Appl. No.: 09/747,920

Amdt. dated October 28, 2004

Reply to Office Action of July 29, 2004

Amendments to the Drawings:

FIG. 4

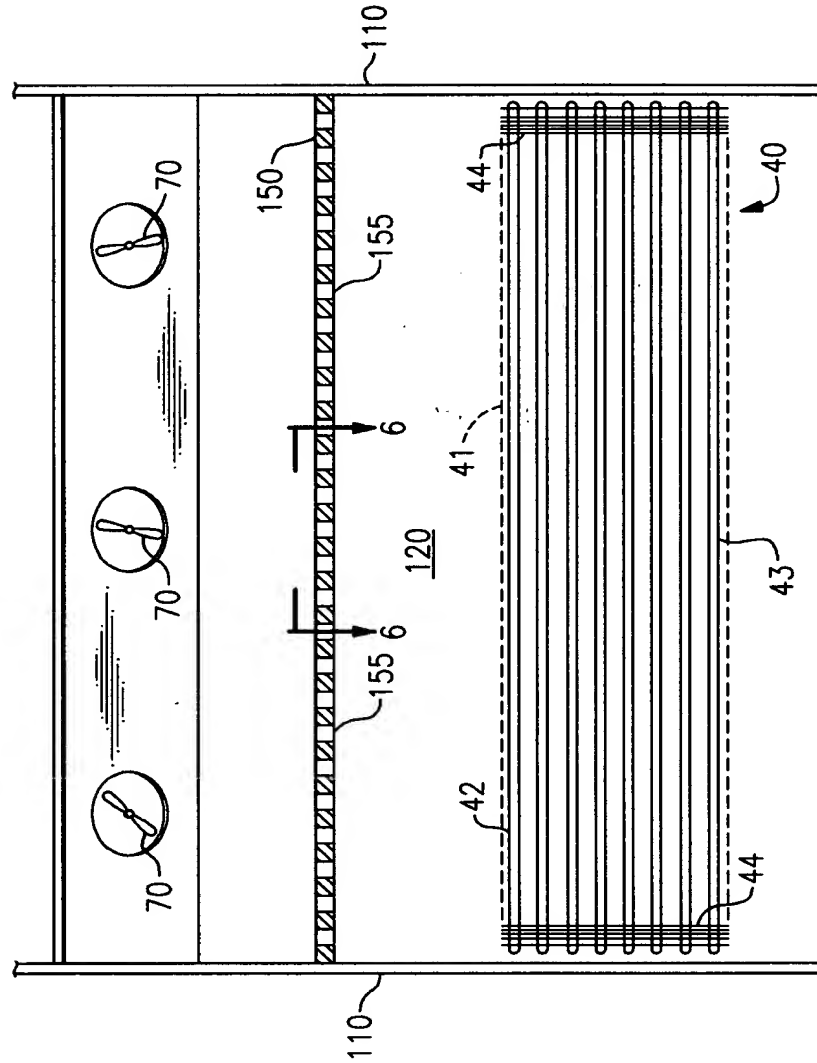
The Replacement Sheet, which has been amended to include new section line 6-6 and to show the fan plate associated with fans 70 with proper shading and orientation, replaces the original sheet including Fig. 4. An annotated sheet showing these changes to Fig. 4 is appended to this paper following the Remarks/Arguments section hereof.

FIG. 6A

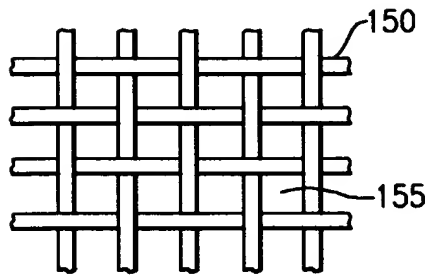
The accompanying New Sheet being added includes new Figs. 6A, 6B and 6C in response to the Examiner's objection the drawings. New Fig. 6A shows the flow baffle 150 as a "screen mesh member" as recited in Claim 4. New Fig. 6B shows the flow baffle 150 as a "slotted planar member" as recited in Claim 5. New Fig. 6C shows the flow baffle 150 as a "honeycomb structure" as recited in Claim 6. Applicants submit that no new matter has been added.
